Response to reviewer2 (egusphere-2024-1477 manuscript)

R1: The distribution of lateral sponge layer which corresponds to the blue region.

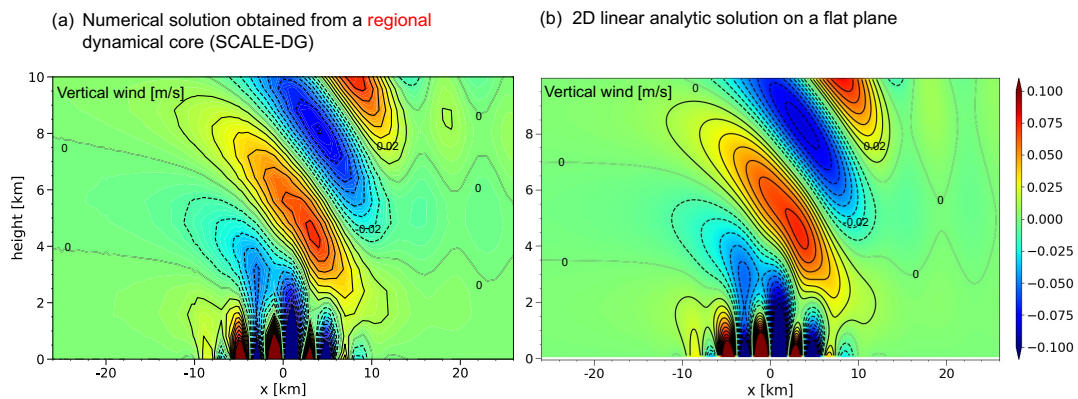
38. line 426: "the 1/4 sector" - what is this?

Thank you for pointing out the wording. We wanted to mean a spherical Lune with the dihedral angle of $\pi/2$ radian as shown in the blue region of Fig. R1. In the revised manuscript, we have removed the phrase because the detail of the lateral sponge layer is described in Appendix B.2 of the revised manuscript.

Fig. R3: Kinetic energy spectra normalized by the result of $p=7$ in LES of planetary boundary layer turbulence.

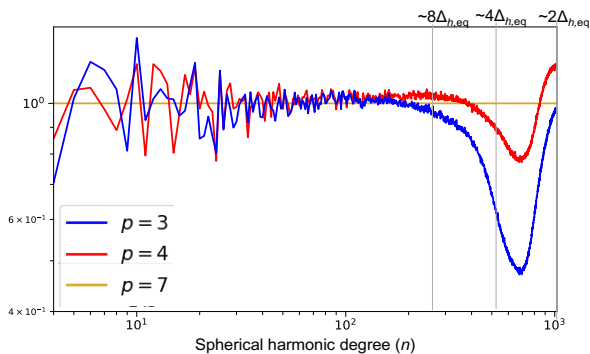
65. line 560: "required polynomial order is $p>3$ " - required for what?; "which is true for results obtained in this study" - make it clear you have shown this by describing the difference for $p=3$.

We would like to mean that $p>3$ is necessary to ensure that the effect of numerical diffusion term is sufficiently small compared to that of the SGS eddy viscosity term at the wavelength longer than eight grid lengths. We agree that the difference among $p=3, 4, 7$ needs to be shown more clearly. Accordingly, we determined the energy spectra normalized by the result of $p=7$ as Fig. R3. In the revised manuscript, we have showed such figures in Figs. 15(b) and C3(b) instead of the spectra normalized by the $-5/3$ power law. In addition, in

lines 621-623 of the revised manuscript, we have modified the corresponding statements as “... $p>3$ is required that the effect of numerical diffusion term is sufficiently small compared to that of the SGS eddy viscosity term at the wavelength longer than eight grid length. This is true for global LES as shown in Fig. 15(b).”
